LAKE PONTCHARTRAIN, LA. AND VICINITY
CHALMETTE AREA PLAN

DESIGN MEMORANDUM No. 5
DETAIL DESIGN
BAYOU BIENVENUE AND BAYOU DUPRE
CONTROL STRUCTURES

LMVED-TD (NOD 25 Jun 68) 7th Ind
SUBJECT: Lake Pontchartrain, Louisiana and Vicinity, Chalmette Area Plan,
Detail Design Memorandum No. 5, Bayous Bienvenue and Dupre
Control Structures

COMMENTS ON DESIGN MEMORANDUM NO. 5, DETAIL DESIGN, BAYOU BIENVENUE AND BAYOU DUPRE CONTROL STRUCTURES, LAKE PONTCHARTRAIN, LOUISIANA AND VICINITY, CHALMETTE AREA PLAN, INCLOSED WITH LETTER, LMNED-PP, 25 JUNE 1968, SUBJECT: LAKE PONTCHARTRAIN, LOUISIANA AND VICINITY, CHALMETTE AREA PLAN, DETAIL DESIGN MEMORANDUM NO. 5, BAYOUS BIENVENUE AND DUPRE CONTROL STRUCTURES

PLAN
EXCAVATION FOR BAYOU BIENVENUE
SCALE: 1"=60'

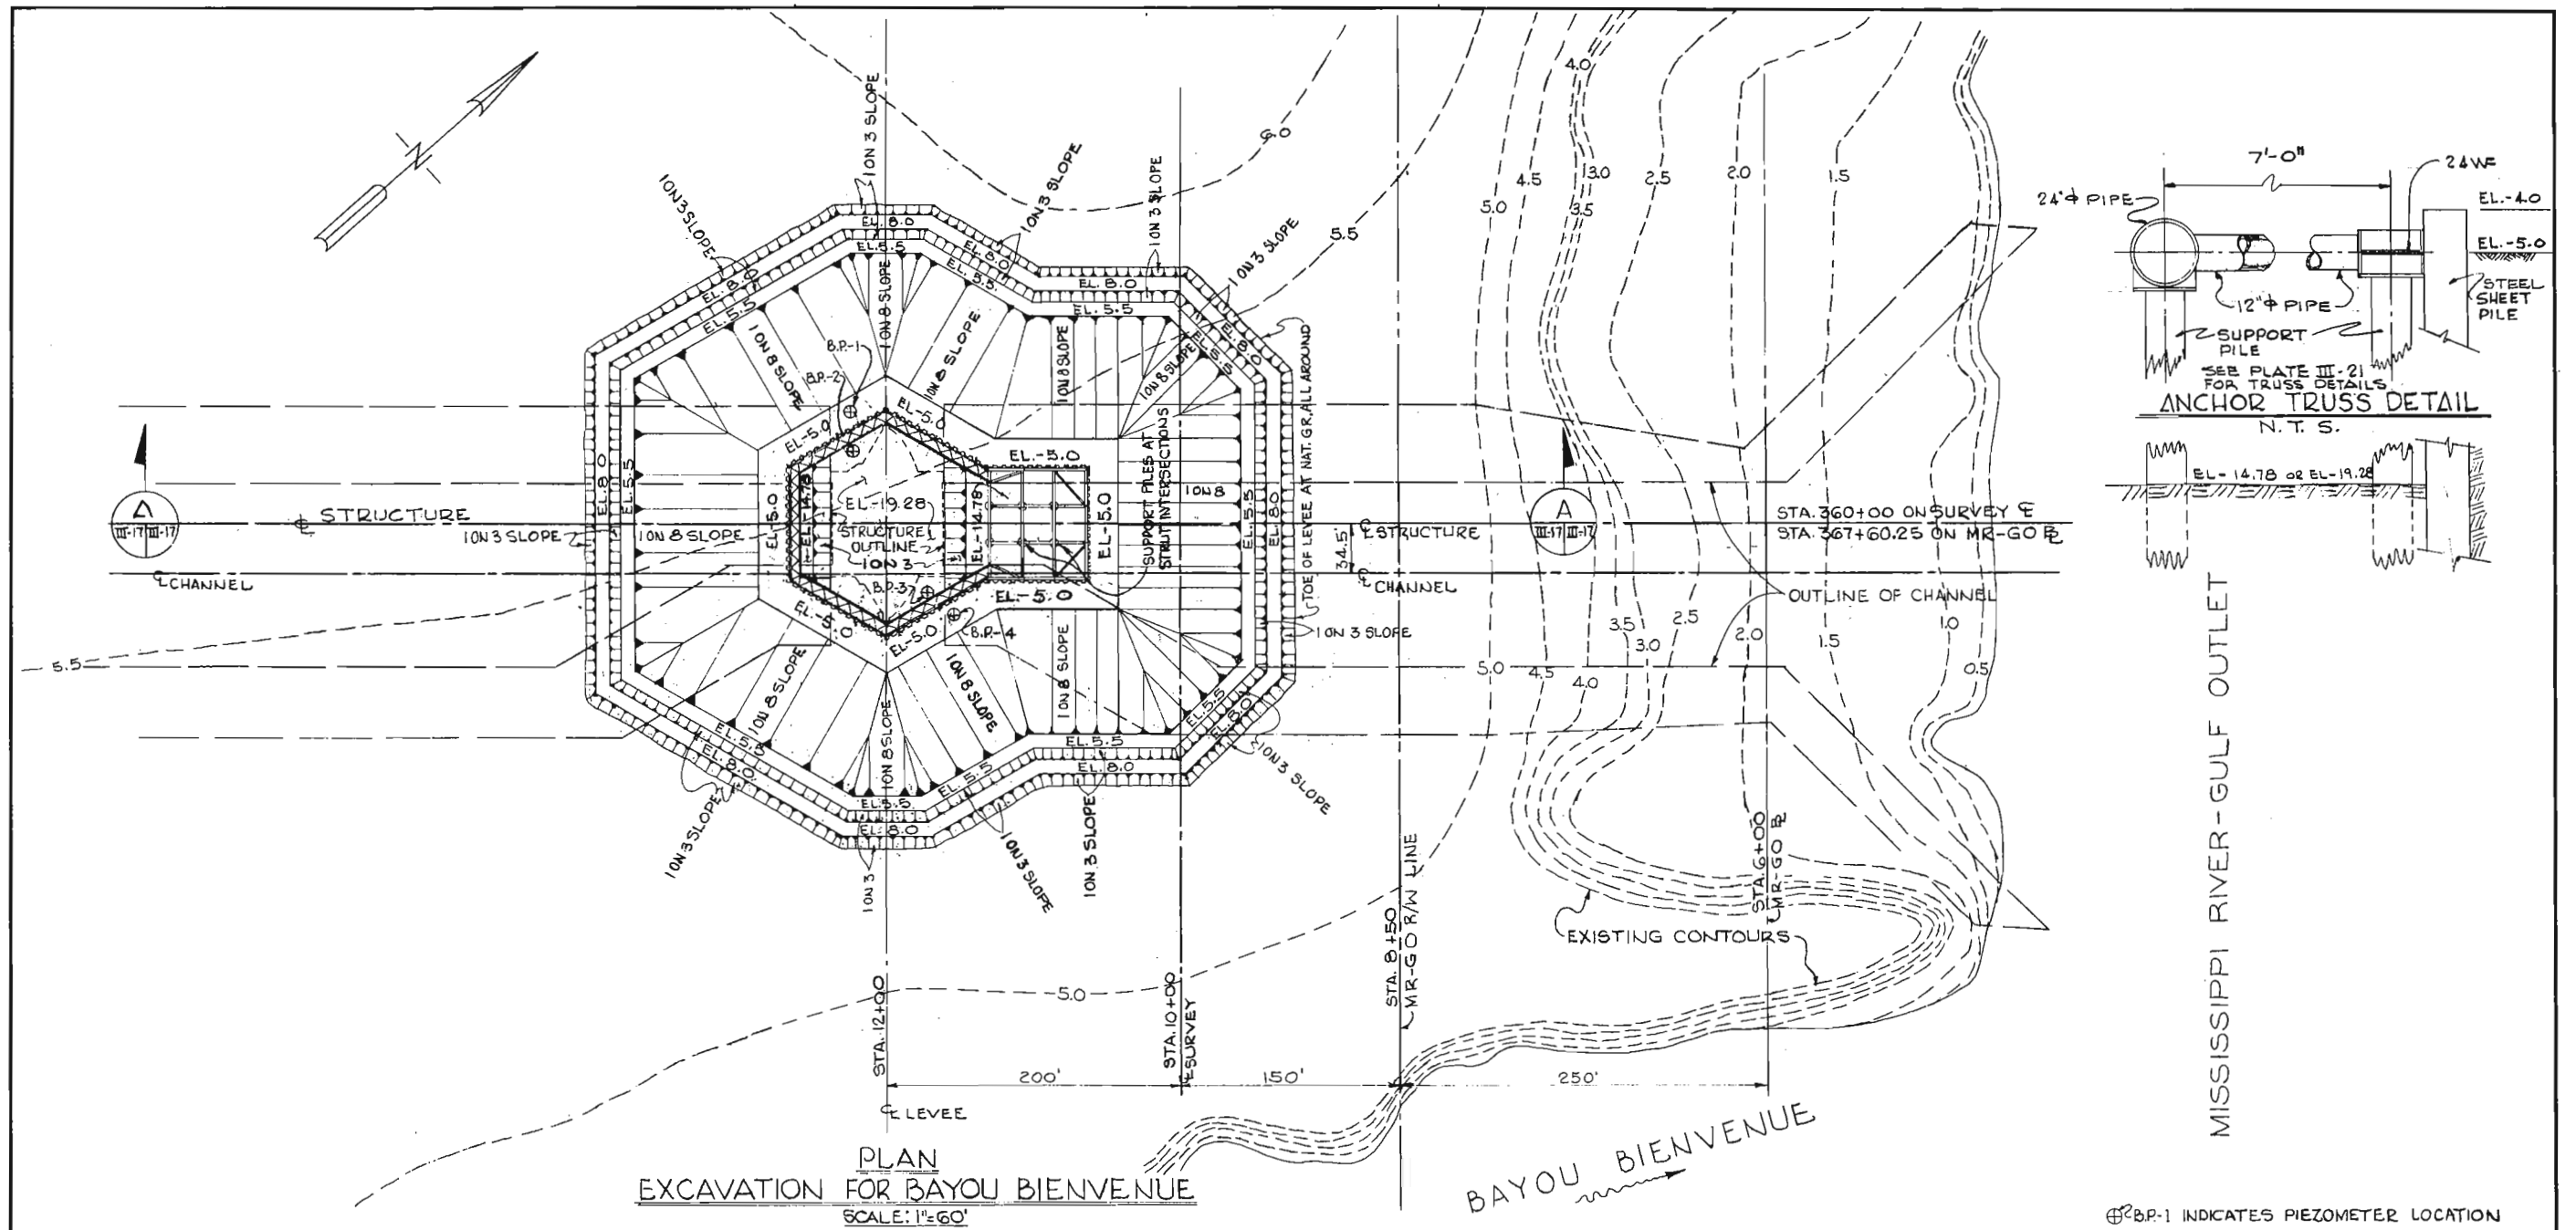
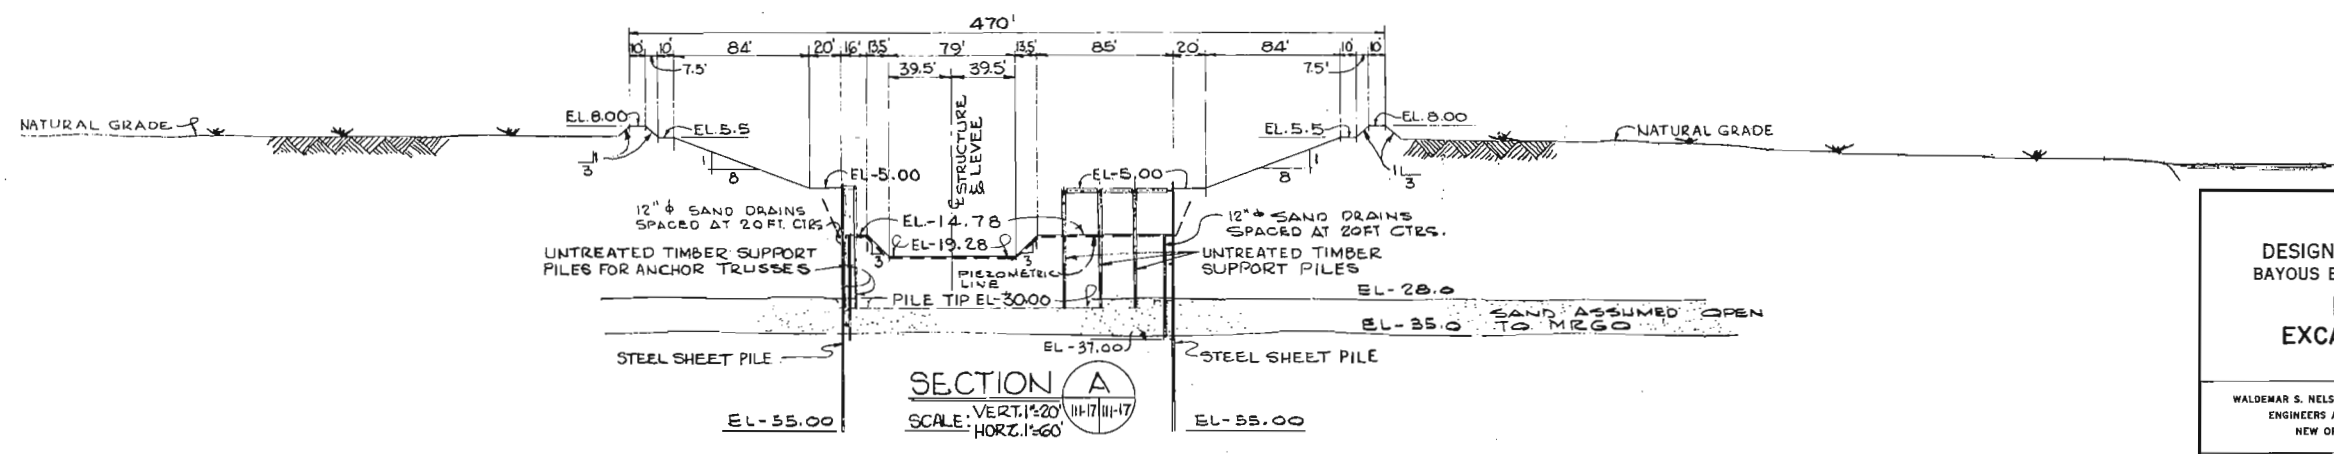
20. Plate III-20. The stability analyses for open excavation should be revised in accordance with comments on the pressure relief systems discussed above.

(11) Par. 9a(1), (2), and (3). A dewatering system using 3-foot well point screens with tip elevations staggered between elevations -31 and -40 was used in order to yield an effective 100 percent well penetration. Accordingly, the cost for dewatering at the Bayou Dupre site for the open excavation plan (plan 1) will increase approximately \$7,000.

NET PRESSURE DIAGRAM
F.S. = 1.25
HORIZONTAL SCALE A
VERTICAL SCALE B

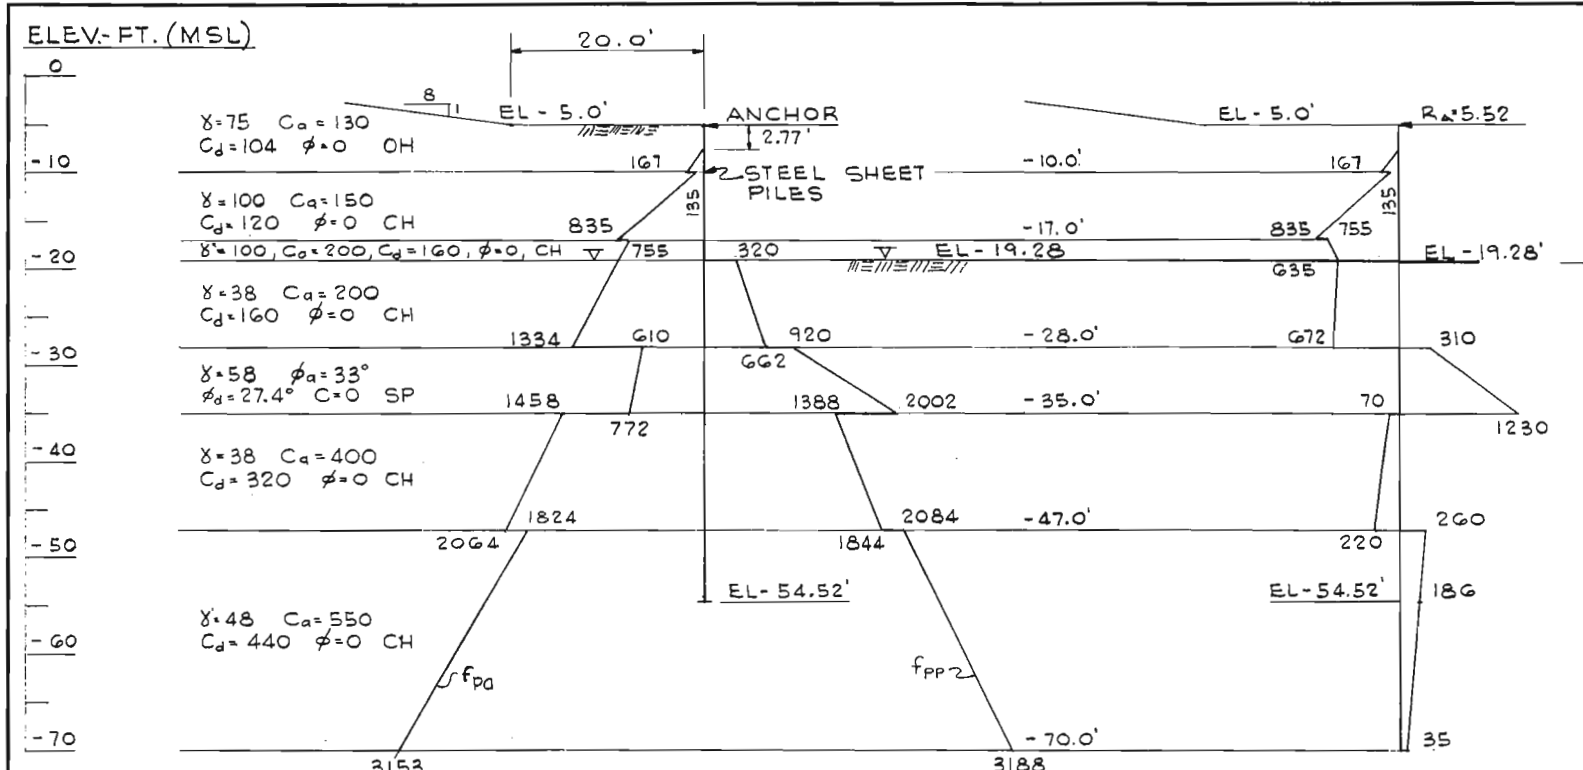
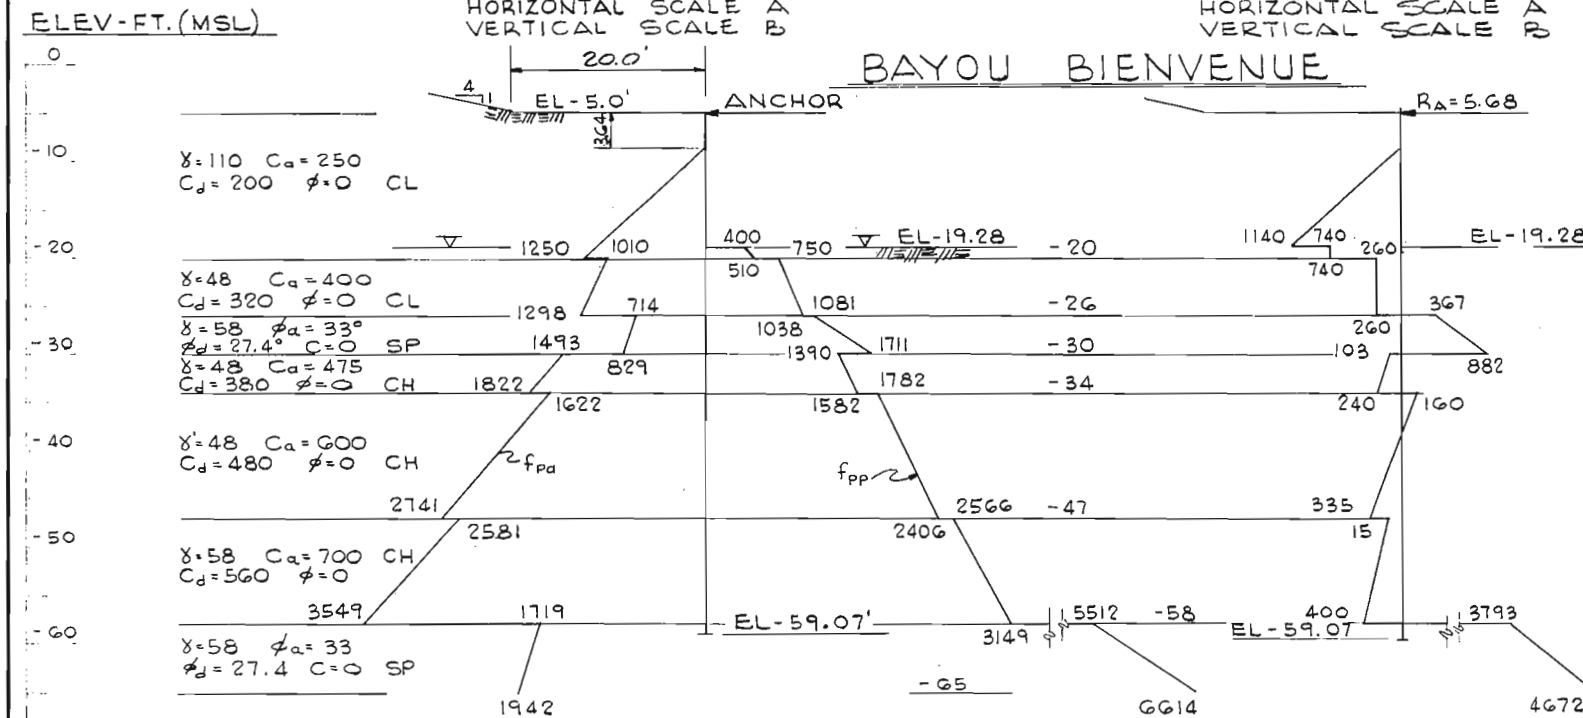
21. Plate III-21. a. In designing the sheet pile inclosure, the influence of the sloping excavation above el -5 and temporary protection levee should be considered. A series of trial wedges can be used to compute the earth forces and pressures on the sheeting and bracing. The assumed water table elevation is considered appropriate for wells or well points to be installed as discussed previously.

(27) Par. 21b. This comment is concurred in.
